December 15, 2017

Reference: Wateridge Village Phase 1B – Blocks 15, 22, and 24 Transportation Overview – Addendum No. 1 City File No.: D07-12-17-0111 Our File No.: 117121 (R-2017-205)

5:/Korsiak & Company/MATTAMY/Ottawa/Wateridge/Site Plan/Dec 17/Block 15 site plan-2017Dec14.dwg

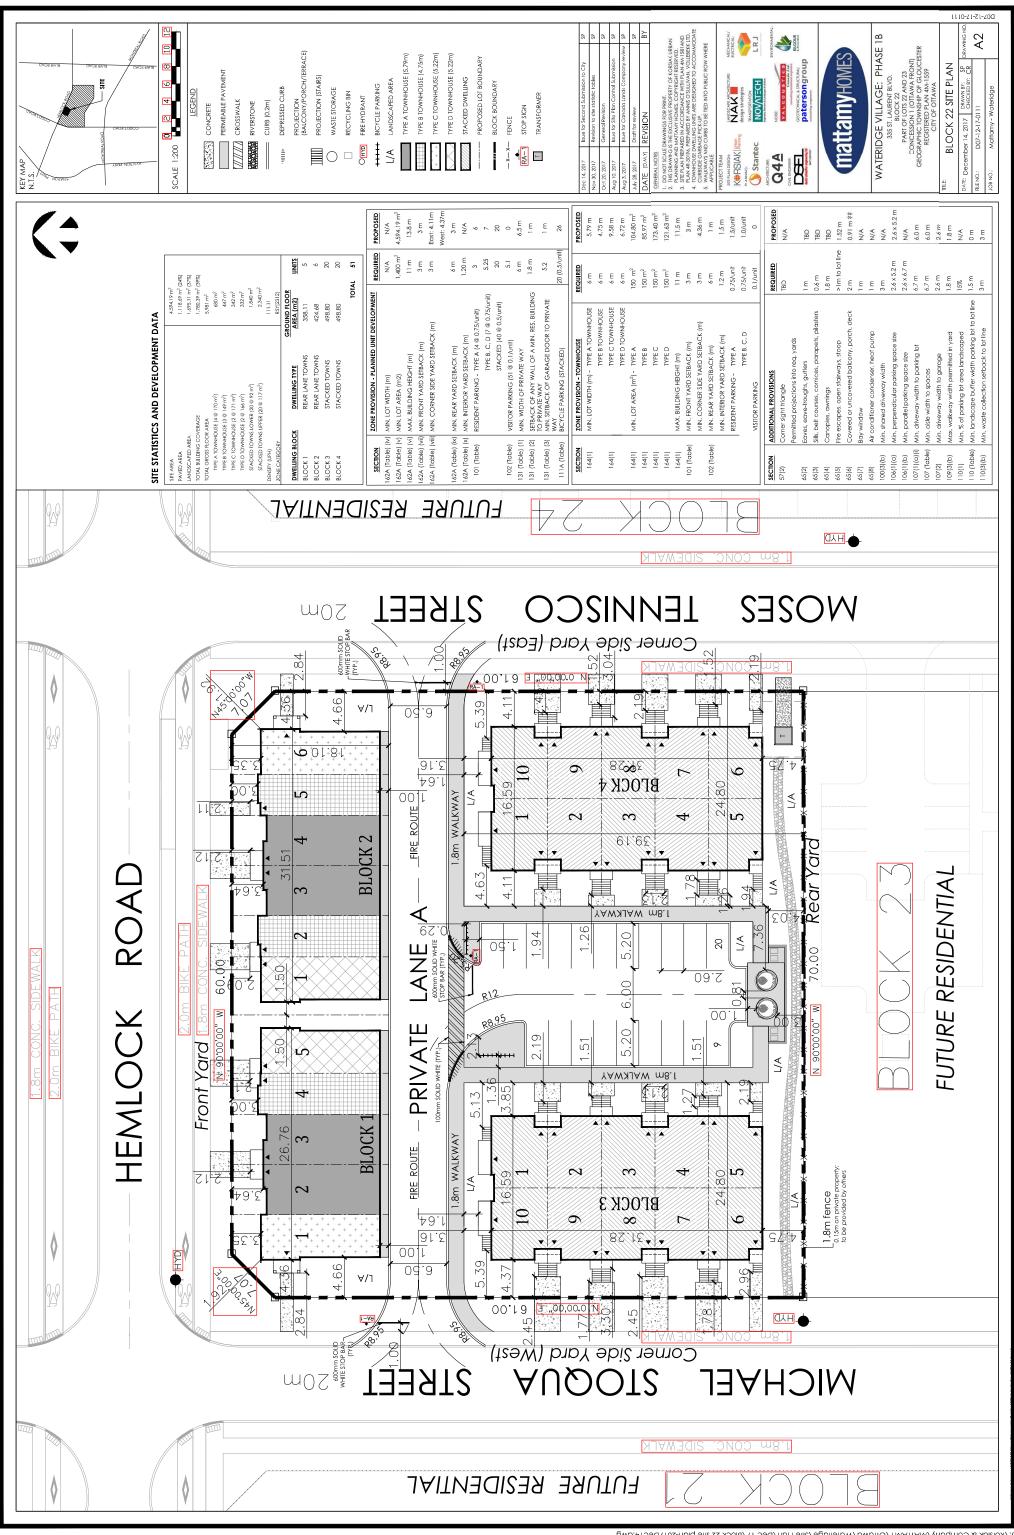
In their comments on the original submission, City staff asked for a description of how cycling and pedestrian movement is anticipated within each block.

As requested by the City, the proposed on-site pavement marking and signage design is now reflected on the revised Site Plans.

All private lanes are expected to operate under low-volume low-speed conditions. The private lanes will function as shared roadways where cyclists and vehicles share travel lanes. Connections to the cycling facilities along the adjacent collector roads (raised cycle tracks along Hemlock and a multiuse pathway along the south side of Mikinak) will be provided at the local road intersections, including Michael Stoqua/Hemlock, Moses Tennisco/Hemlock, and Mikinak/Squadron. On-site bike rack locations continue to be refined as the detail design advances, however the intent is to disperse the racks throughout the blocks for maximum usage and convenience. Updated bike parking requirements are outlined in **Section 5.0** below.

Sidewalks at all private lane connections to the adjacent local roads will be depressed and continuous across the accesses.
